Cambridge City Council

## **DEVELOPMENT PLAN SCRUTINY SUB-COMMITTEE**

## **4 Ridgeon's, Cromwell Road Planning and Development Brief SPD (Pages 5 - 212)**

## **5 Draft Mitcham's Corner Development Framework SPD (Pages 213 - 290)**

**Figure 1: Ordinance Survey of Ridgeons site ownership**

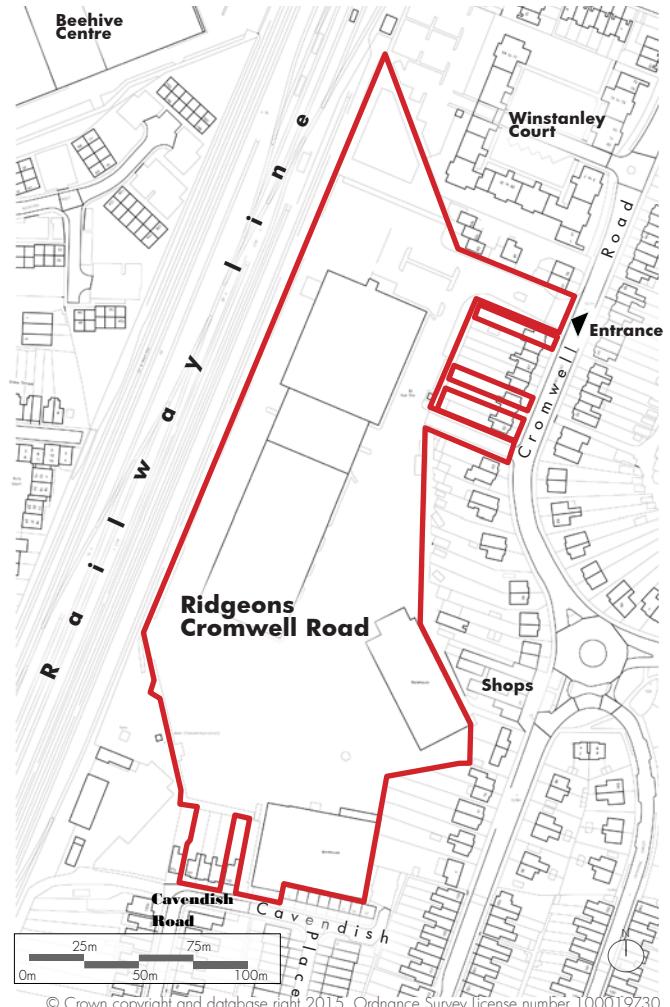
Comments noted. This SPD relates to the Ridgeons site only, as defined in Figure 1. This SPD cannot comment on the future development potential of other sites in the locality. Future development on other sites will be controlled by the Local Plan with any future applications that are made considered on their merits.

Figure 65: Roads, public transport, cycle path and access plan

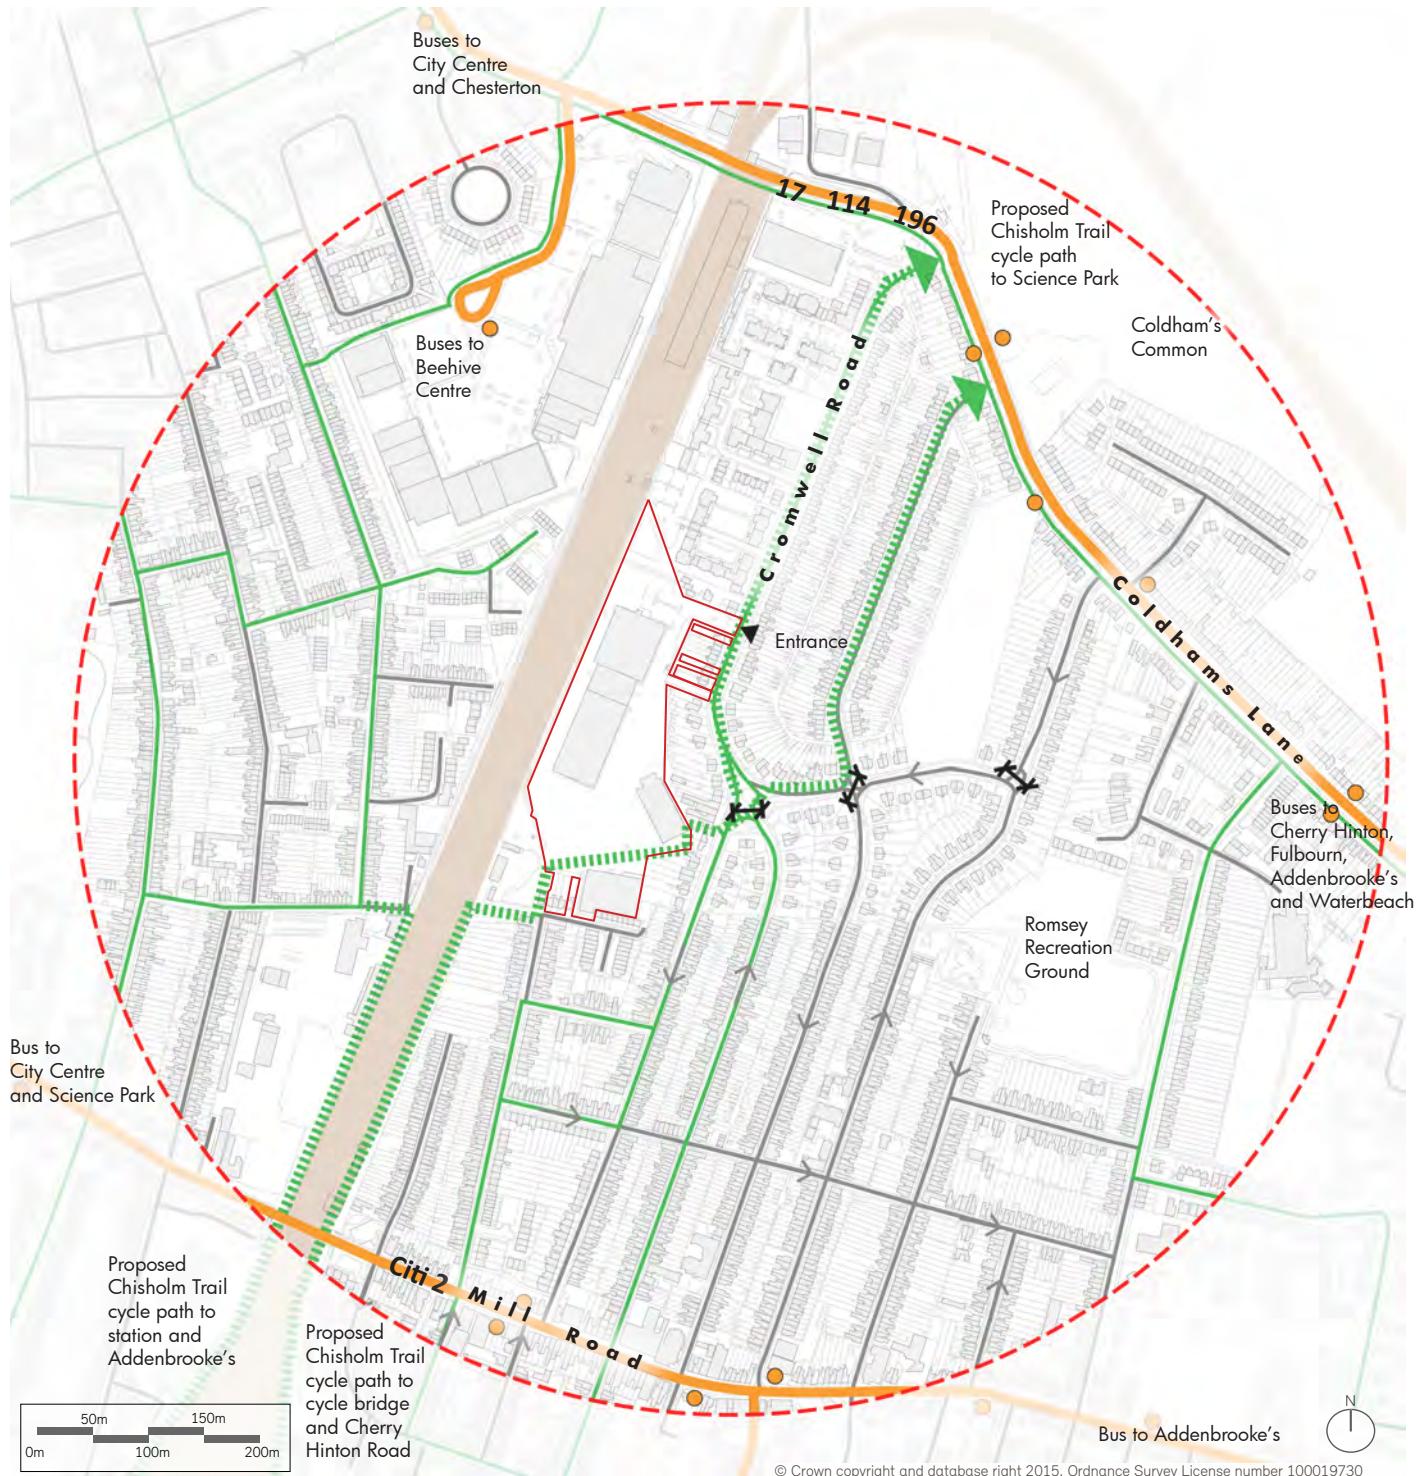
Figure 65 should be updated to reflect the latest route of the proposed Chisholm Trail.

Update Figure 65 to reflect the latest route of the Chisholm Trail.

**Figure 67: Section 1 - Cavendish Road**

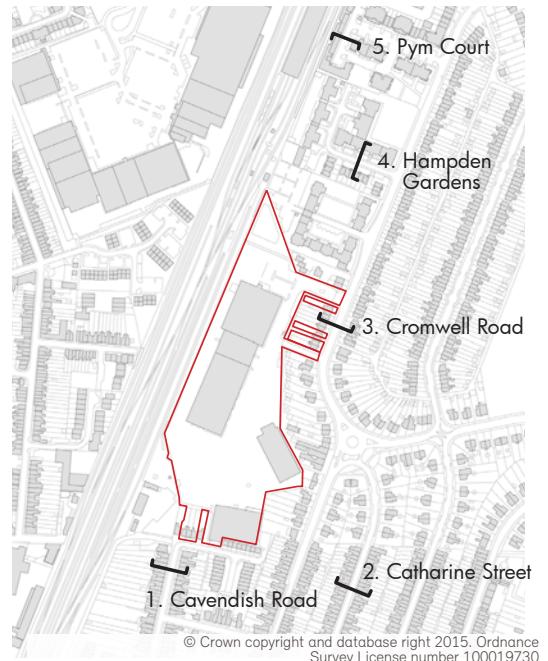
It would also be more realistic to say in Figure 67 on page 34 that not only two cars can't pass but that a car and a cycle cannot pass.

Add text to bracketed text of Figure 67 "and vehicle and cycle passing is in places constrained."

**Comments note. Additional text has been added to Figure 67 to address these points. The precise treatment of the Chisholm Trail within Cavendish Road will be detailed within the Planning Application to be made for this section of the route. The development of the Ridgeons site itself will be unlikely to generate sufficient cycle movements to raise a highway safety impact but is accepted that if the Chisholm Trail also passes through the site (as is planned) the potential use of Cavendish Road needs to be assessed in detail as part of the Planning Application.**

**Figure 74: Challenges to delivering a bridge**

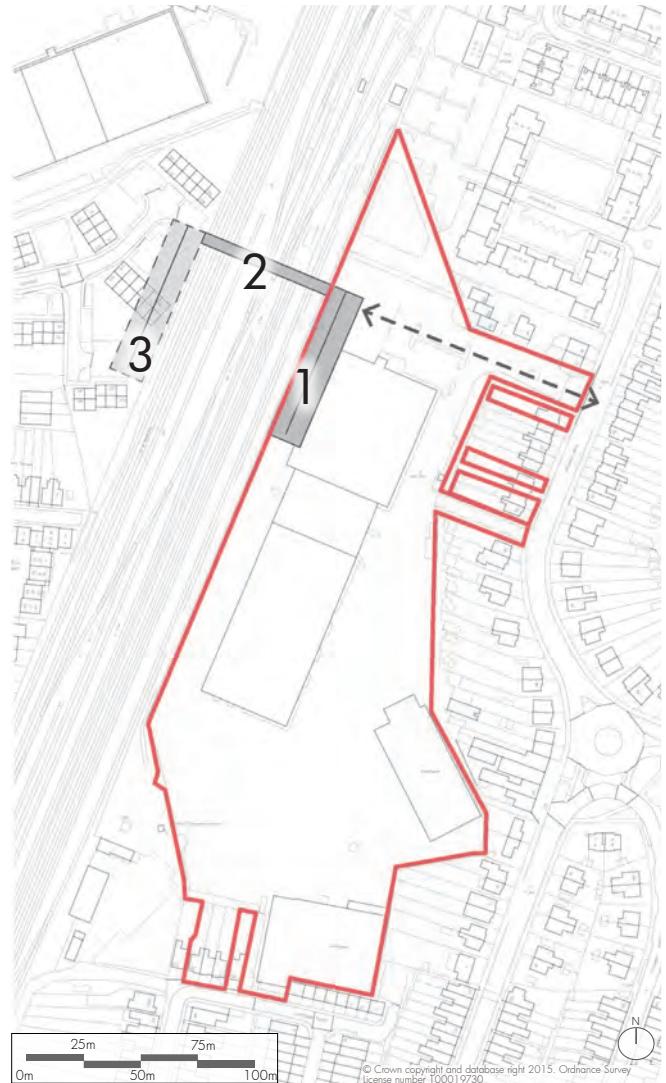
**Comments noted.** There are three existing crossing points. Mill Road, the Carter Bridge and Coldham's Lane. The development of this site will not in its own right generate sufficient demand to warrant the construction of a bridge due west in the manner shown in Figure 74. The difficulties associated with such a bridge being provided are set out within the SPD. If a deliverable option to secure a bridge is able to be delivered as part of wider studies being undertaken in respect of the Chisholm Trail, future Planning Applications will be able to reflect and respond to these.

**Comments noted.** The development of this site will not in its own right generate sufficient demand to warrant the construction of a bridge due west in the manner shown in Figure 74. The difficulties associated with such a bridge being provided are set out within the SPD. If a deliverable option to secure a bridge is able to be delivered as part of wider studies being undertaken in respect of the Chisholm Trail, future Planning Applications will be able to reflect and respond to these.

It is suggested that paragraph 2.6.13 be amended to add the words "...as shown in Figure 74" after the word "bridge". This paragraph should be expanded by adding an additional sentence to read "If a means of crossing the railway is able to be delivered as part of wider improvements being delivered by the Chisholm Trail, the future development of the Ridgeons site should make reasonable efforts to coordinate with such an initiative."

**Figure 75: Open space plan**

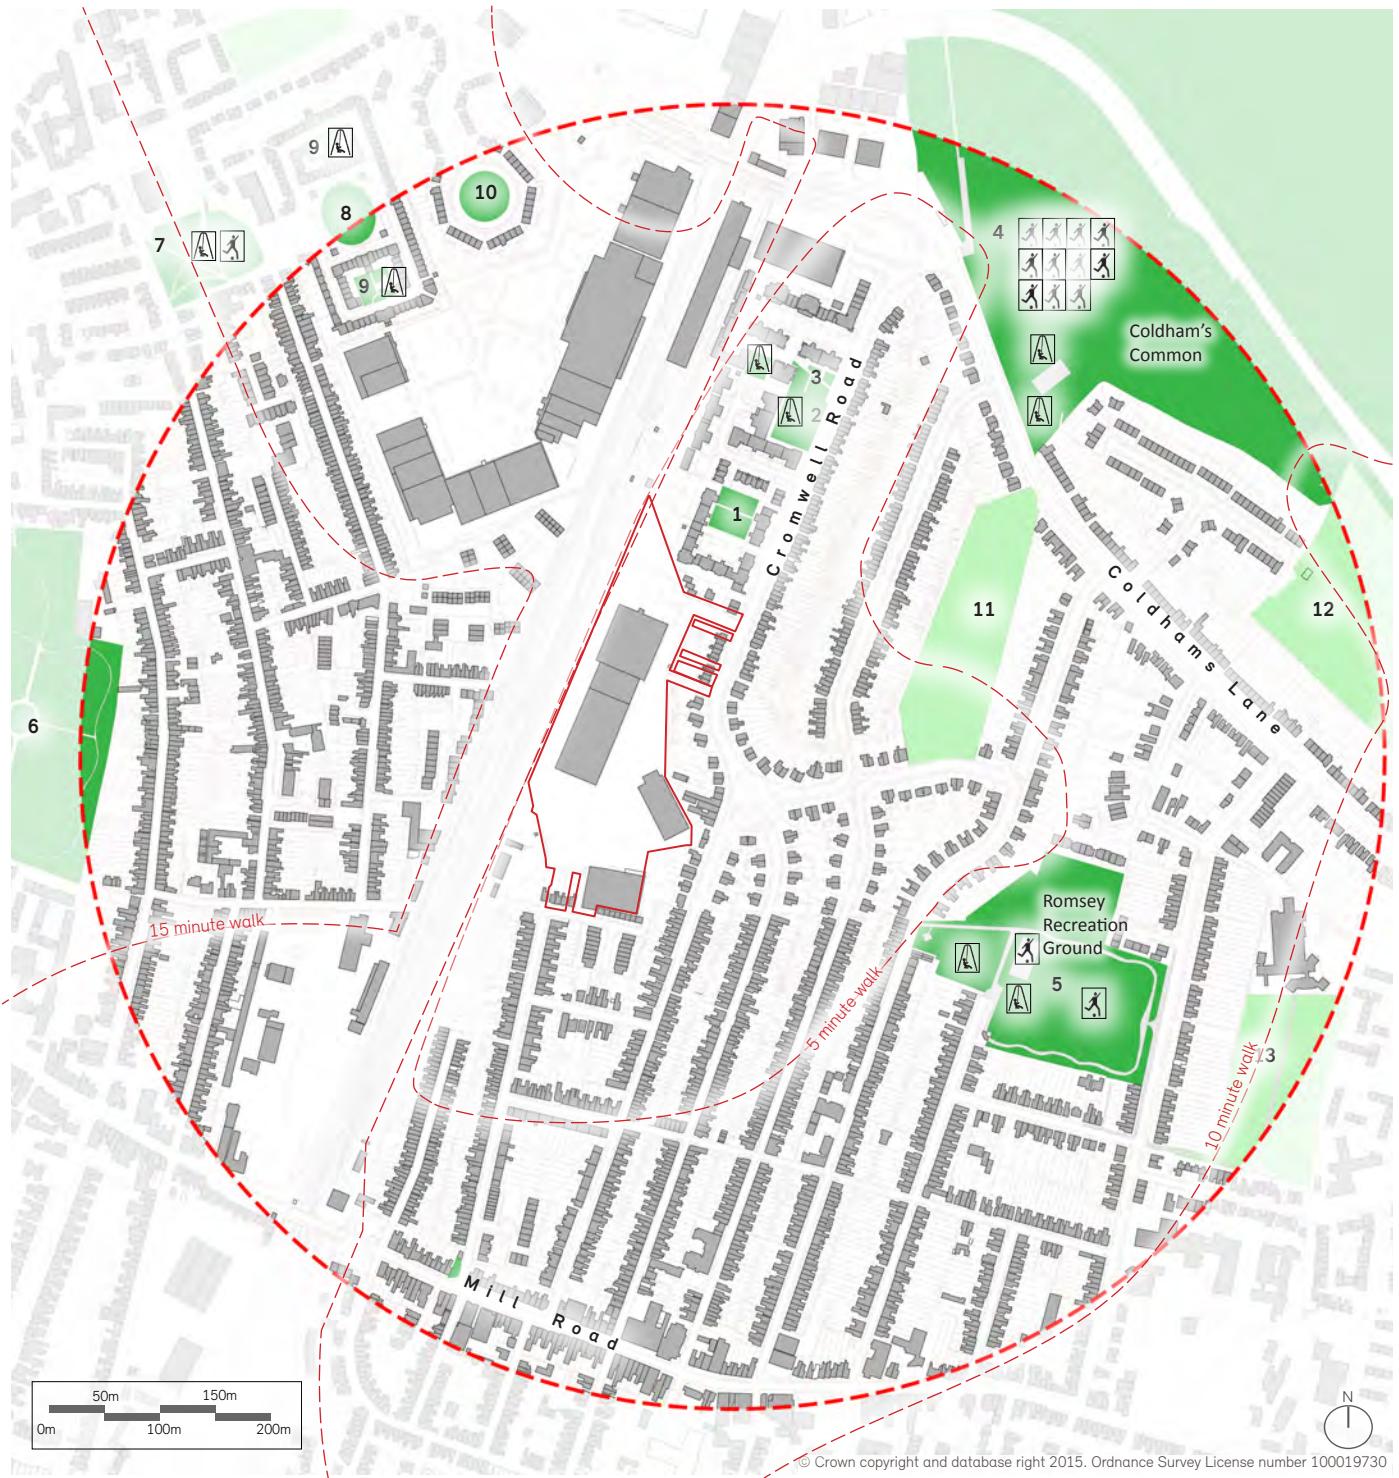
despite the availability of open space adjacent to the site, it is vital that sufficient and well-designed landscaping is available within this site. Figure 136 depicting a more undulating and organic green space is preferred to the overly simplistic linear form.

**Figure 107**

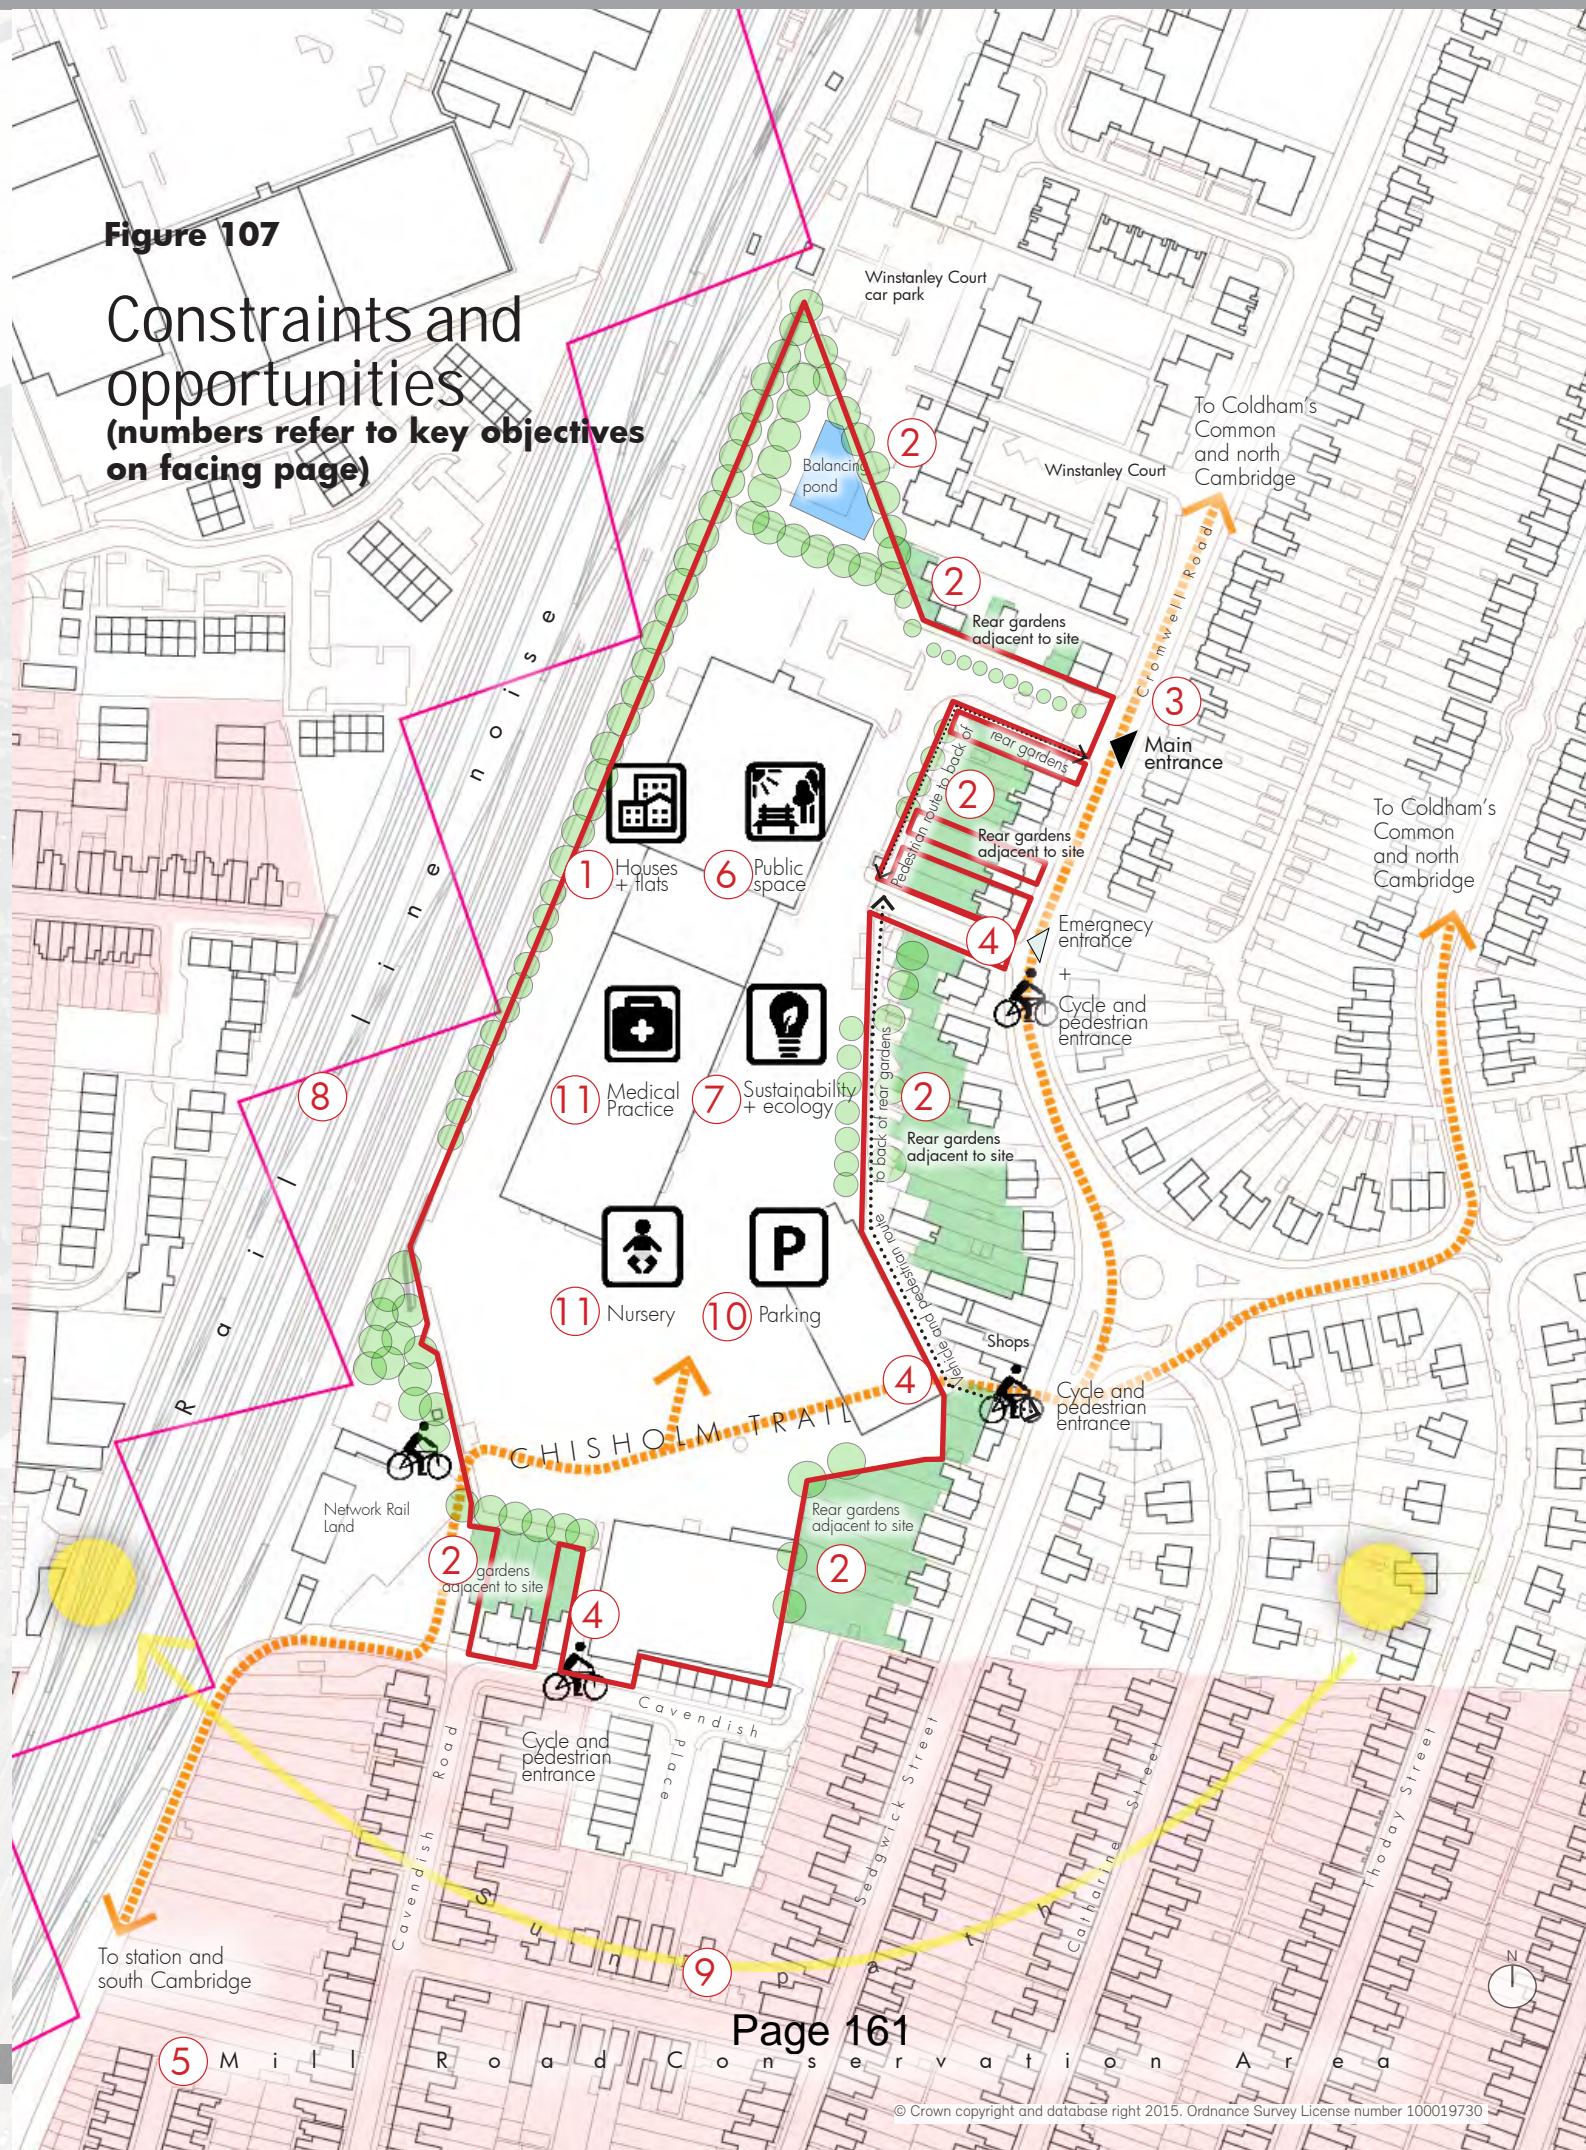
The suggestion on pages 36 Figure 72, on page 52, Figure 107, and again on page 65, Figure 111 all suggest a primary network would allow cycles to enter Cavendish Road with an expectation I suspect that they access Mill Road. This is a move away from the plan on page 33 and raises concerns if allowed to happen without a rethink of the arrangements on Cavendish Road.

Comments noted. Figure 107 shows Cavendish Place. An annotation for Cavendish Road will be added to the road running north-south. The point at which the road name changes is not marked. It is not considered necessary or desirable to show this level of detail as part of the context information as to do so would over complicate the drawing as many other such points of clarification would be needed to be added to the plan also. It is also not possible to show all extension that have been added to nearby properties. The context plans rely on OS based data which will not be up to date. It is not possible to accurately update each and every change to nearby properties that may have occurred since the OS data was issued. The context information should not be treated as an accurate reflection of building forms that exist off site. A detailed assessment of the site's context would be undertaken visually during the consideration of any planning application.
